NL-16-115

SUBJECT: Request for Additional Information Regarding Review of Compliance with Order EA-12-049 "Order Modifying Licenses with Regard to Requirements for Mitigation Strategies for Beyond-Design-Basis External Events" and Order EA-12-051 "Modifying Licenses with Regard to Requirements for Reliable Spent Fuel Pool Instrumentation" (TAC Nos. MF0744/5 and MF0737/8)
Indian Point Units Number 2 and 3
Docket Nos. 50-247 and 50-286
License Nos. DPR-26 and DPR-64

- Attachment: 1. Indian Point Responses to NRC During Review of Order EA-12-051
2. Indian Point Response to August 30, 2016 Discussion of Required Information Regarding EA-12-049 and EA-12-051

Figure 1: IP3 SFPI Fan House Cable Routing Sketch (not to scale)

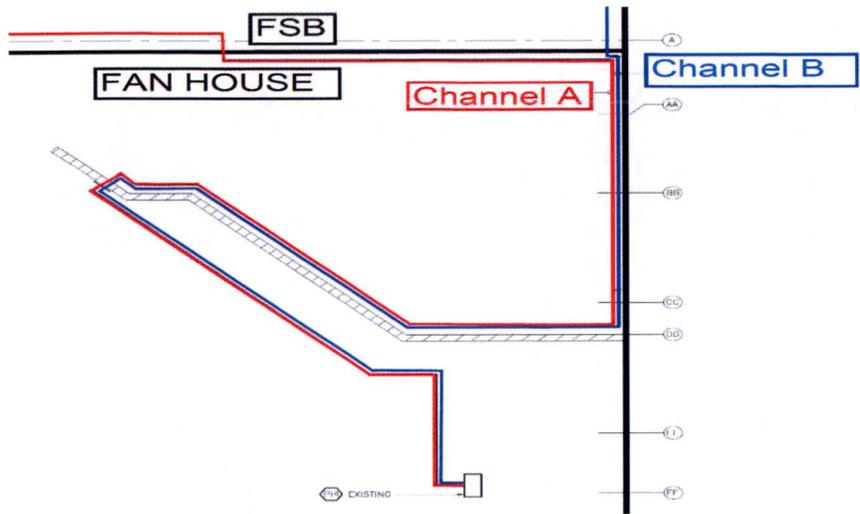
Please provide a description of the protection provided for the cabling routed along the exterior of the fuel building for Channel B of IP2 and IP3. Also, please provide a sketch to illustrate the remaining cable routing from the fuel building wall penetrations to the processor units for Channel A and Channel B for IP2 and IP3.

For IP3, Channel A will penetrate through the west wall into the Fan House. The Fan House is a Seismic Class 1 structure that is protected against adverse weather conditions. The Channel B route will follow the east wall to the south wall, follow along the south wall and penetrate on the south side of the doorway between the Fan House and the Fuel Storage Building (FSB). Once outside the FSB, the two conduit runs will converge near the door between the FSB and the Fan House. Each channel will maintain plant design channelization requirements by remaining in their dedicated conduits. The two channels will be run down to the 67'-6" Elevation of the PAB Fan House. Both conduits are to be routed through the existing penetration south of the door between the Fan House and the upper mezzanine of the pipe penetration area. Once through the penetration they will be routed down the hall to the Gas Analyzer Rack, which is part of the retired in place Hydrogen Recombiner Panel. Per IP3 calculation IP-CALC-13-00083, "Evaluation of Conduit Supports for FLEX Program Spent Fuel Pool Level Instrumentation," all conduit supports (74 in total) are designed for seismic loads and seismically mounted to seismic structures. The IP3 SFPI cable routing within the Fan House is shown graphically in Figure 1. More detailed routing drawings are also included in the response to RAI #17.

Figure 3: Unit 2 SFPI General Arrangement Drawing 1

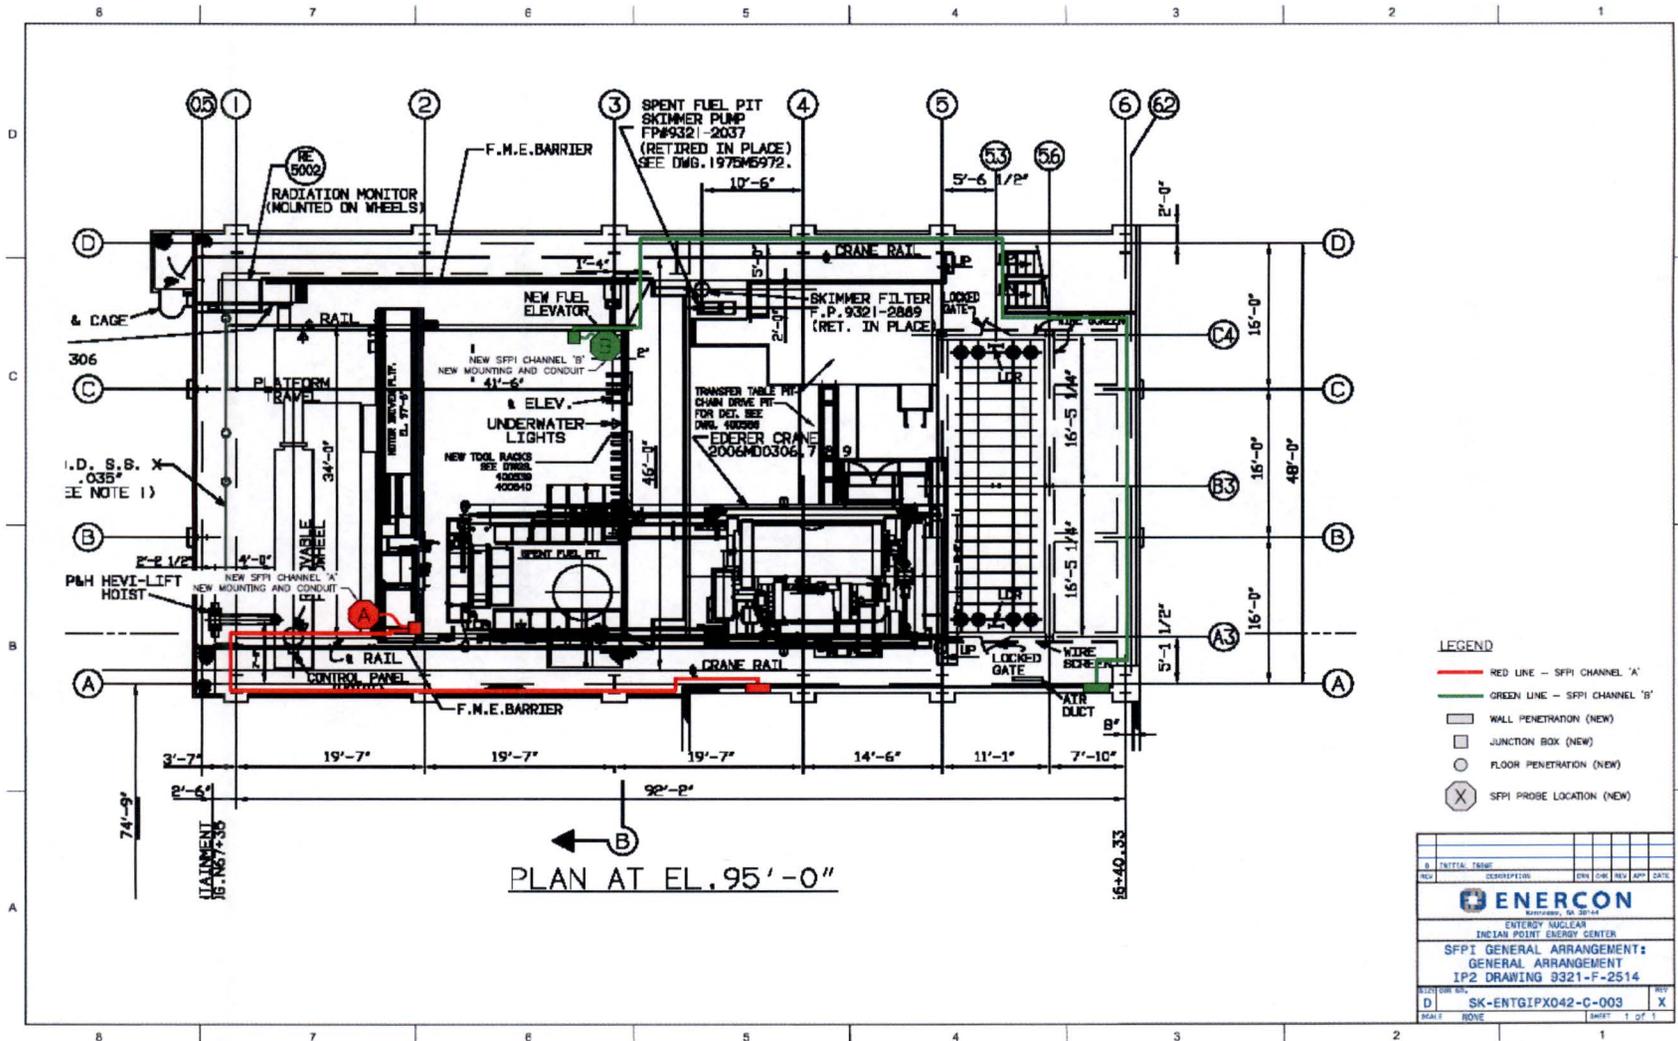
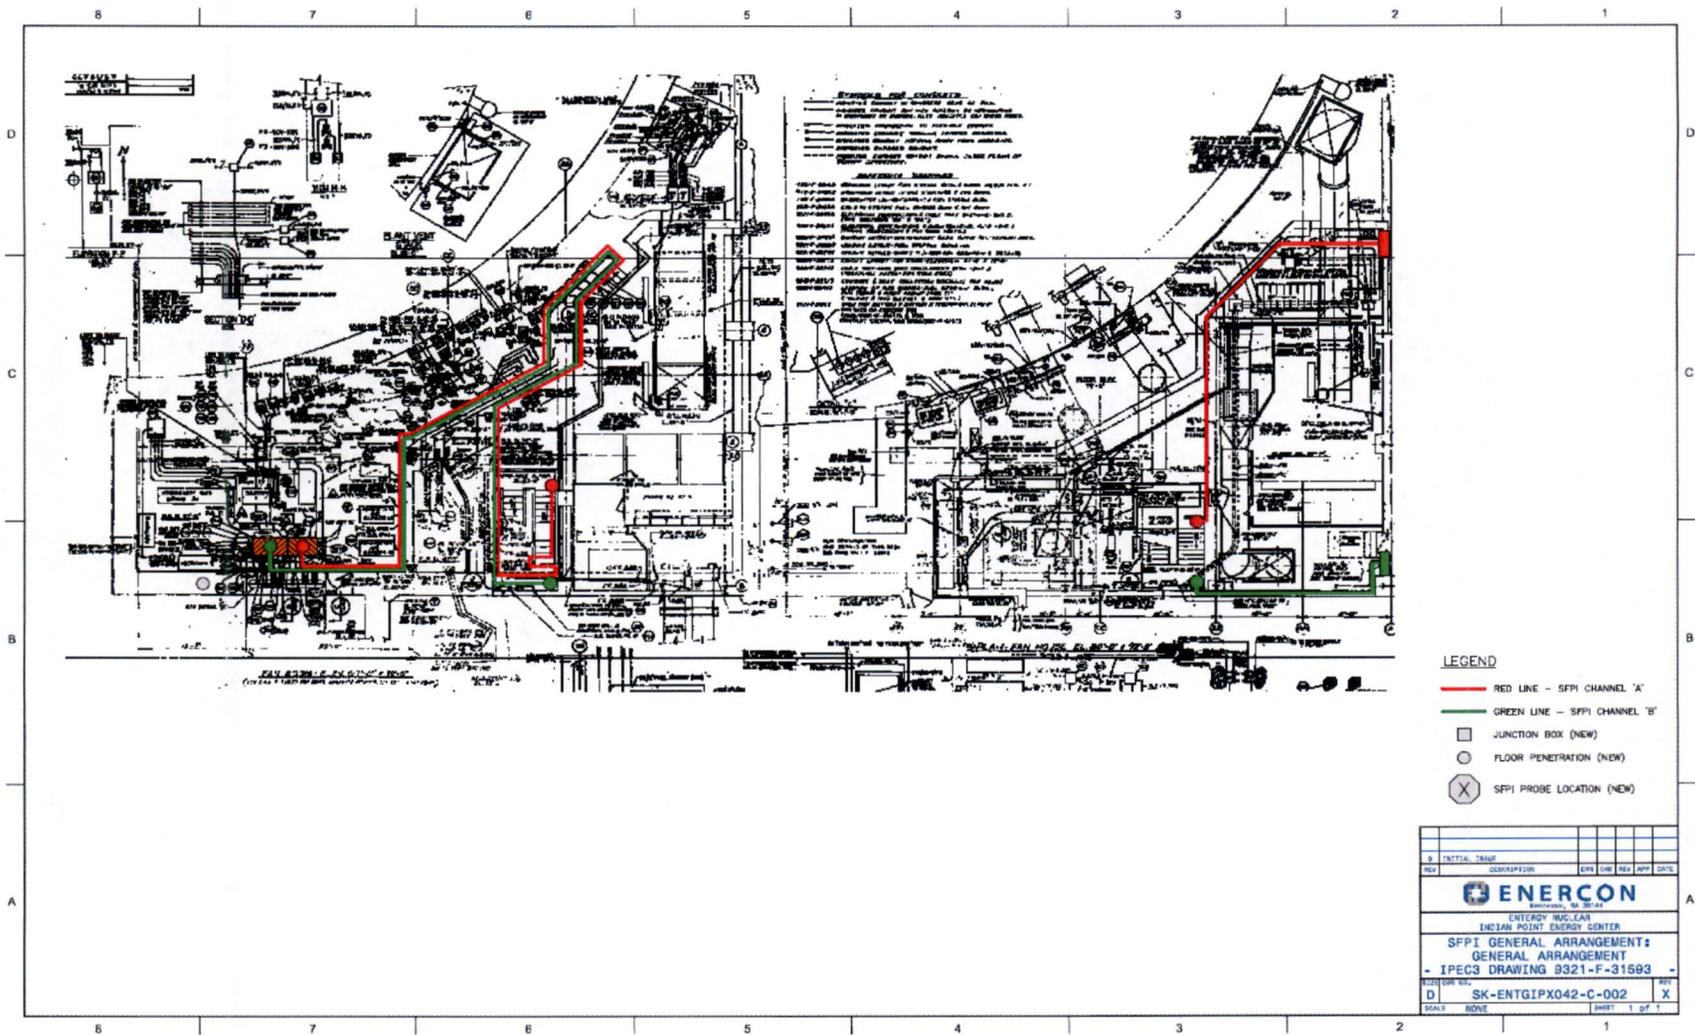
Please provide a final configuration of the IP2 and IP3 locations/placement of the primary and back-up SFP level sensor/probe, and the proposed routing of the cables that will extend from the sensors toward the location of the read-out/display device.

Figure 3 through Figure 6 depict the Unit 2 & Unit 3 final cable routing and probe locations.
